March 24, 2016

**Re: Red and Bonita Mine Bulkhead Closure Evaluation; D&A Job No. CG-0628.001.00**

This letter is in response to a request by the US Environmental Protection Agency (EPA) to comment on the Colorado Division of Reclamation, Mining, and Safety (DRMS) report "*Design Basis for Water Impounding Concrete Bulkhead, Red and Bonita Mine, San Juan County Colorado*" dated November 4, 2015. Specifically, we have been asked to comment on the potential impacts of closing the Red and Bonita Bulkhead valve (installed in September 2015) on other adits, bulkheads, and streams in the upper Cement Creek area. To aid in our evaluation, we reviewed mapping and 3D modeling conducted by DRMS and conducted a literature review of geologic maps, papers, and reports on the hydrology and the existing bulkheads. This letter is a revision of our previous report, dated February 17, 2016, and incorporates additional flow data along with text corrections.

<b>AMERICAN TUNNEL AND MINES</b>	
Profile	
<b>DEERE &amp; AULT</b> CONSULTANTS, INC.	FIGURE NO. <b>2</b>
DATE: <b>3-24-16</b>	SCALE: <b>AS NOTED</b>

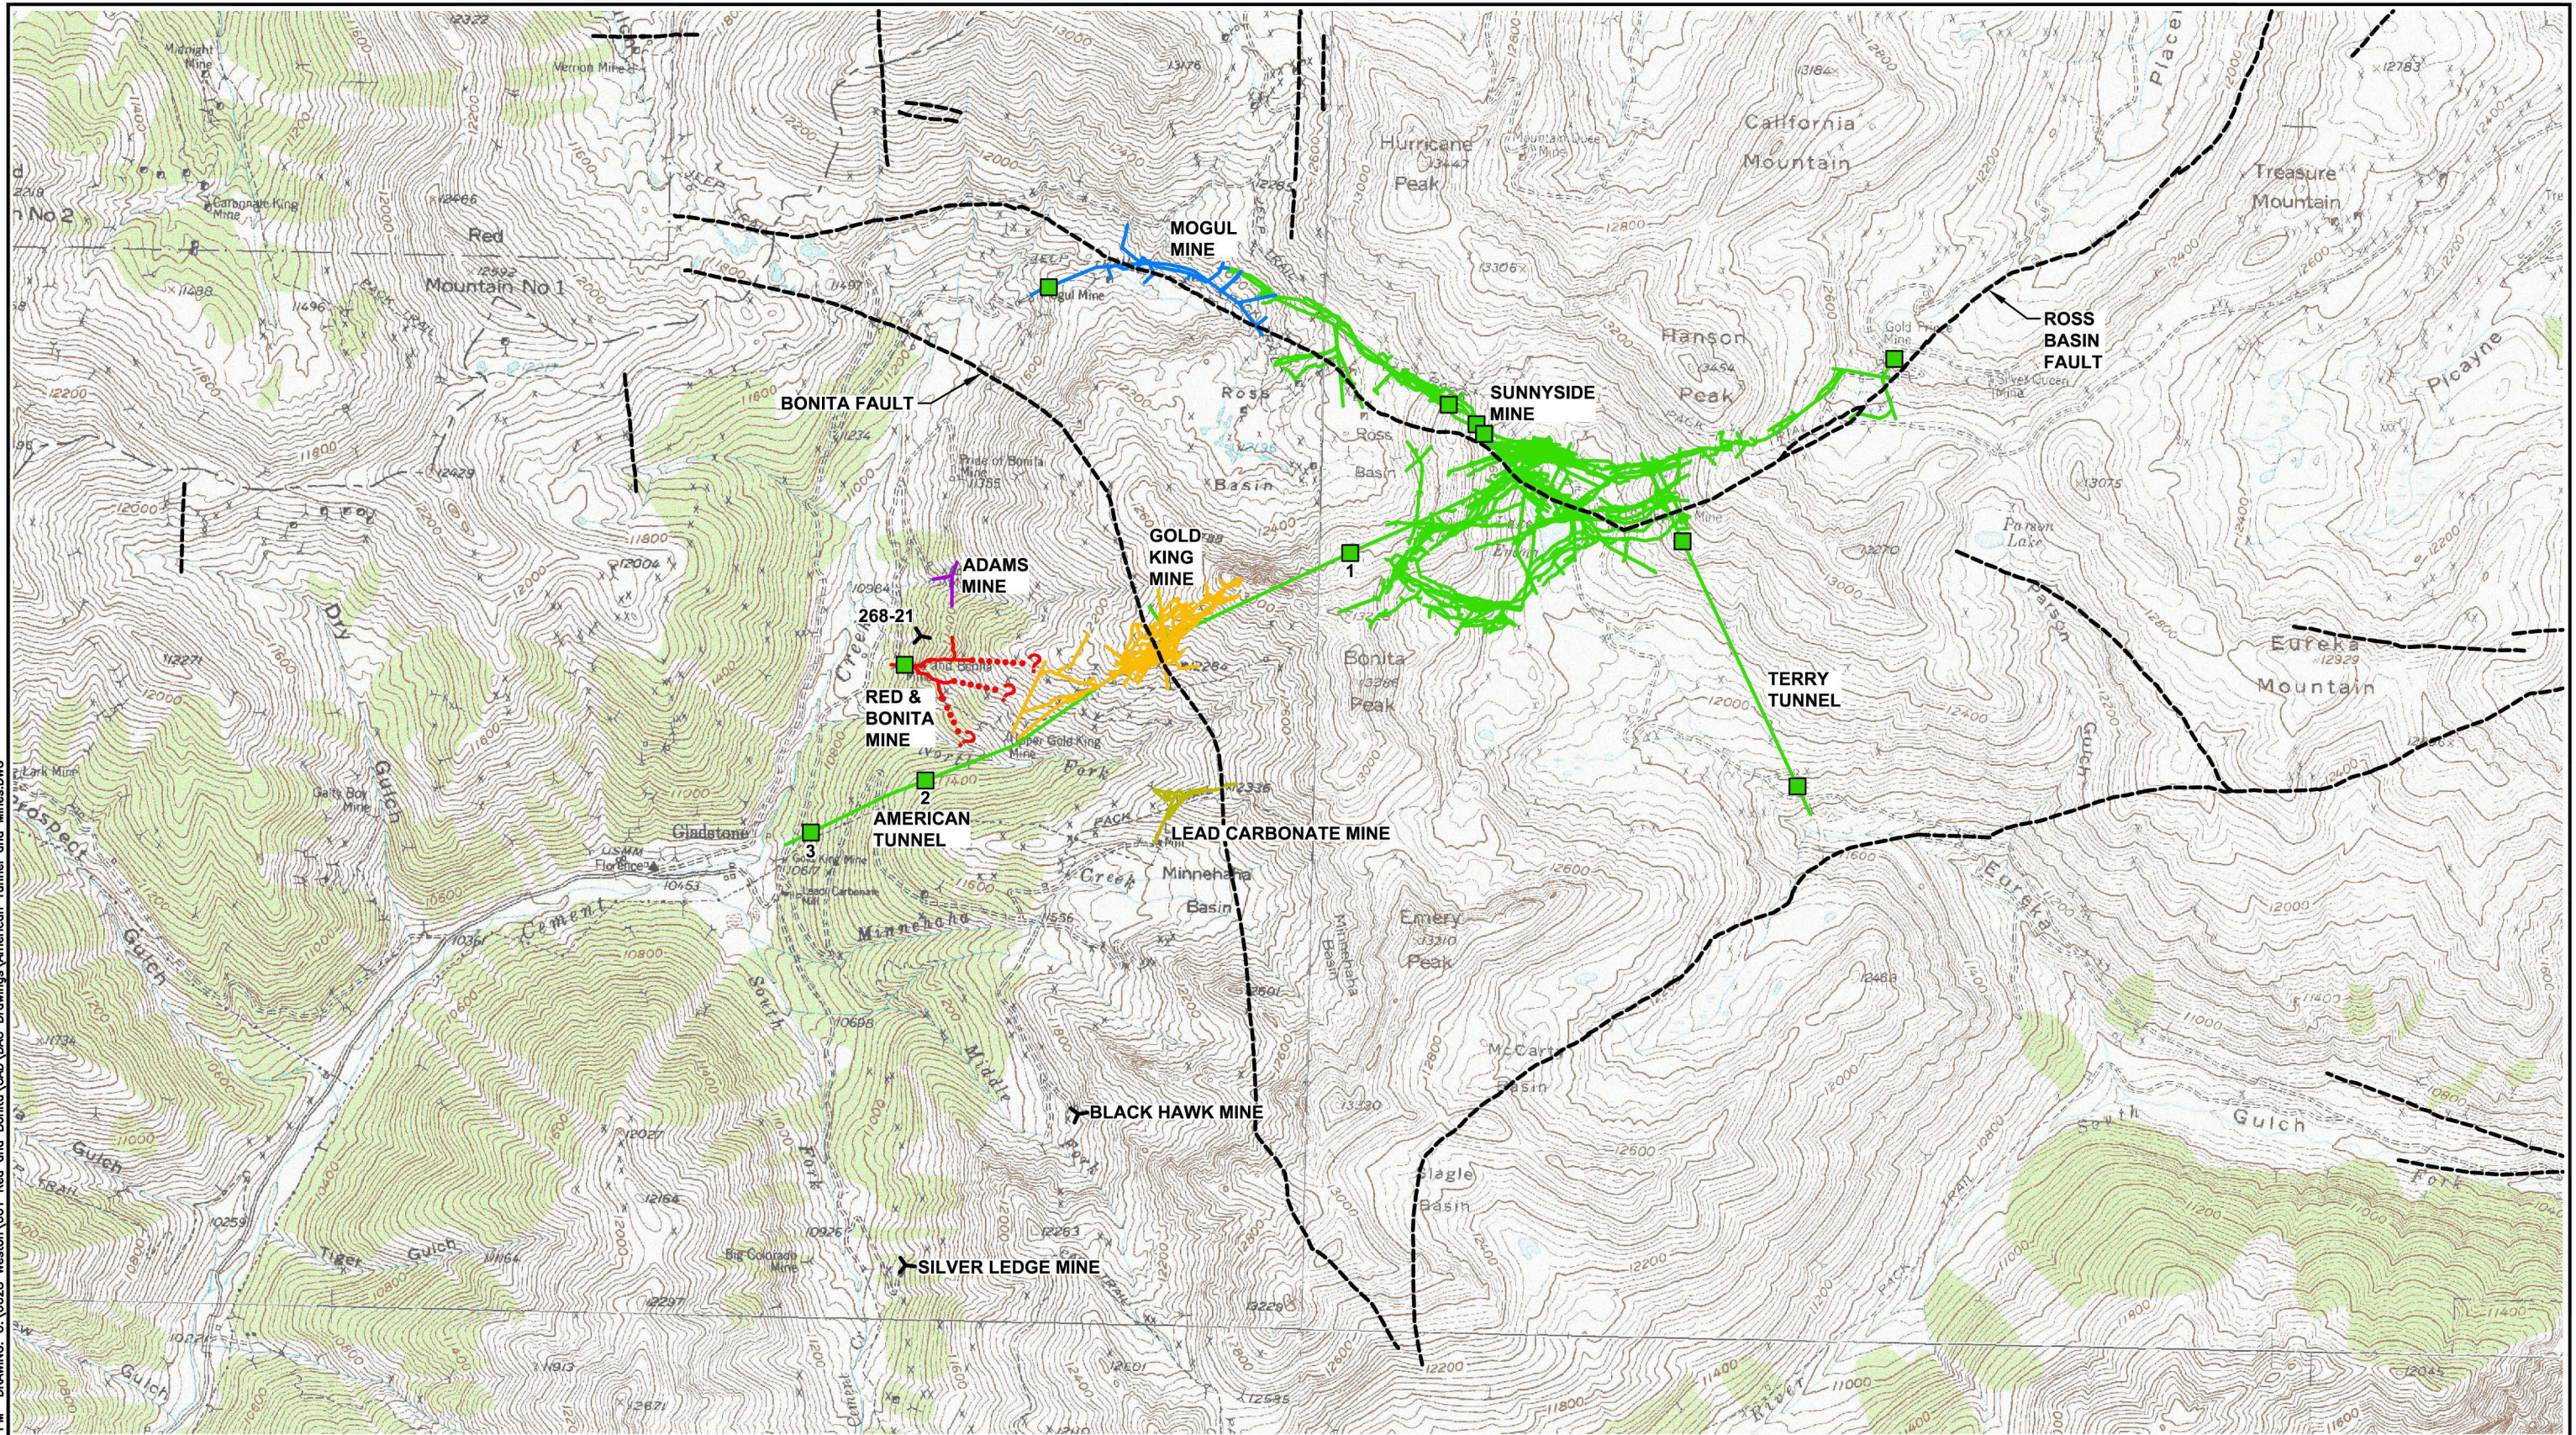
**Figure 2** presents a cross-section along the American Tunnel, showing the ground surface, mine workings, bulkheads, and the estimated groundwater elevation. This phreatic surface is based on three points: the Sunnyside mine pool in 2001 (last reading), the pressure behind Bulkhead 2 in 2002 (last reading), and the fact that water continues to flow out of the Gold King Mine (550 gpm steady flow over several months strongly suggesting a groundwater connection, not surface drainage). Water pressure behind Bulkhead 3 was, to our knowledge, never measured. The actual current groundwater table is unknown.

The cross-section in **Figure 2** shows that the bulkheads were designed with adequate capacity for the anticipated water heads. The problem is that there is no monitoring in-place to check actual groundwater heads and confirm that they are within the design limits. In order to check current groundwater levels, measure the impact of closing the Red and Bonita Bulkhead, and monitor the pressure on American Tunnel Bulkhead 2, a vibrating wire piezometer could be installed in the fracture zone along the North Fork of Cement Creek, near the Gold King waste pile.

Whether or not the Red and Bonita valve is closed, we recommend reestablishing access to Bulkhead 3 by mucking out the American Tunnel from the portal to the bulkhead and installing ground support as needed. Then annual inspections, much like for high hazard dams, could be carried out to look for signs of seepage past or through the bulkhead. If problems were discovered then or in the future, the area could be formation grouted and the bulkhead extended. Clearing out the American Tunnel and surveying it would also aid in establishing the drilling location for tunnel monitoring behind Bulkhead 3.

<b>AMERICAN TUNNEL AND MINES</b>	
Plan	
<b>DEERE &amp; AULT</b> CONSULTANTS, INC.	FIGURE NO. <b>1</b>
DATE: <b>3-24-16</b>	SCALE: <b>AS NOTED</b>

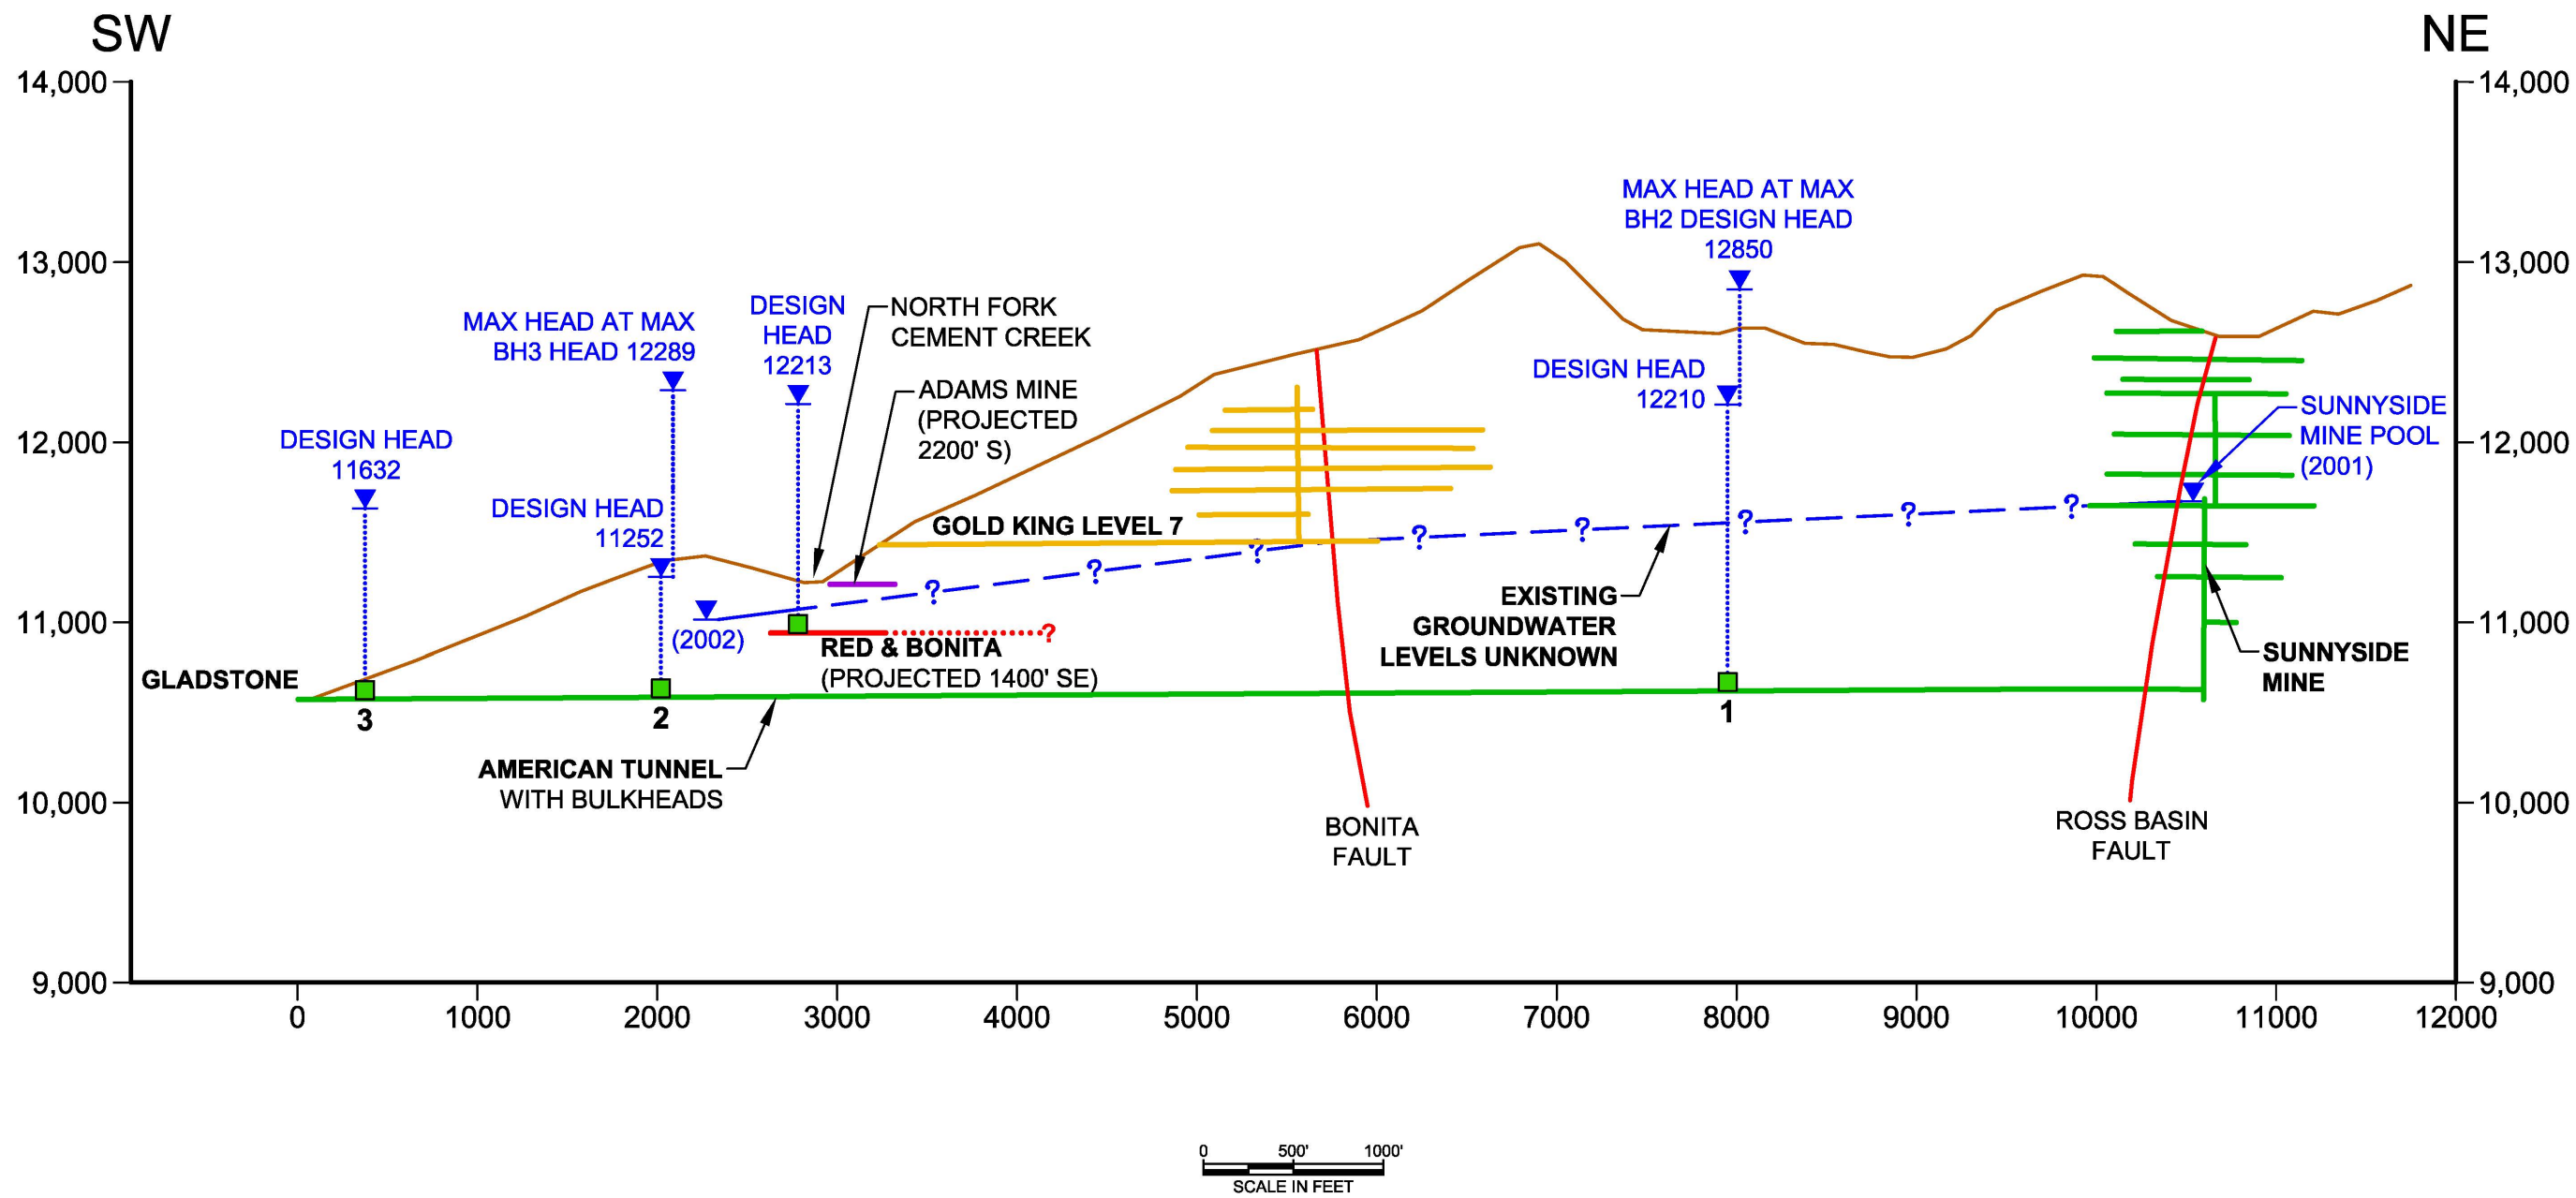
The most critical structures in this area are the bulkheads in the American Tunnel, as shown in **Figure 1** and **Figure 2**. Bulkhead 1 was designed to control the Sunnyside Mine pool. Bulkhead 2 was designed to control inflow from the wet fracture zone that manifests itself as the North Fork of Cement Creek on the surface. Bulkhead 3 was designed to impound minor flows within the first section of the tunnel. The three bulkheads work together to form a system with redundant capacity. A summary of the bulkheads is found on **Table 2**. Based on the design reports and verbal comments by others, the bulkheads were placed in specifically selected locations where the rock was of good quality and jointing was limited.
